1.0 Introduction

- 1.1 This Technical Note (TN04) has been prepared by Motion in response to the LLFA comments issued on 17th December 2025. It provides the technical information requested by the LLFA and highlights matters for consideration by the LPA, including how the proposed drainage strategy integrates with the overall site layout and delivers the requirements of the adopted HDC Local Plan.

Project:
Land East of Mousdell Close
Ashington
Title:
Drainage Strategy

Scale: 1:500 (@ A1)
 Drawing: 2504072-0501
 Revision: P06

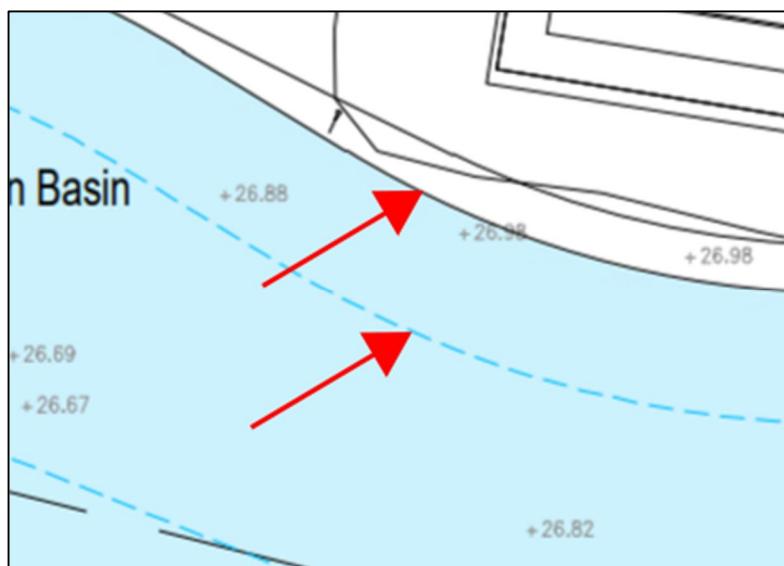
- 2.13 In their letter of 17th December 2025, the LLFA remarked that "*the design of the SuDS basin [is of] particular concern. For example, the excerpt below shows that whilst some edges of the proposed basin has sloped edges (to the northeast) other sides do not.*"

- 2.14 We would like to clarify this interpretation of the plans. The Drainage Strategy Report and supporting hydraulic calculations define the SuDS basin as having a 1-in-3 batter on all sides to full depth. This is illustrated on the strategy plan by the solid black line and inward blue dashed line, as picked out by the red arrows on the excerpt below.

- 2.15 The embankment shown along the northern edge of the basin does not represent the inward batter of the basin; rather, it is the top (cover) level of the basin tying into the surrounding natural topography. What WSCC has interpreted as a small and inconsistent internal bank is, in fact, the cut-and-fill profiling around the basin, designed to ensure it functions correctly in three dimensions (with comparable profiling evident on the southern side). Reference should be made to the appended sectional drawings for clarification.
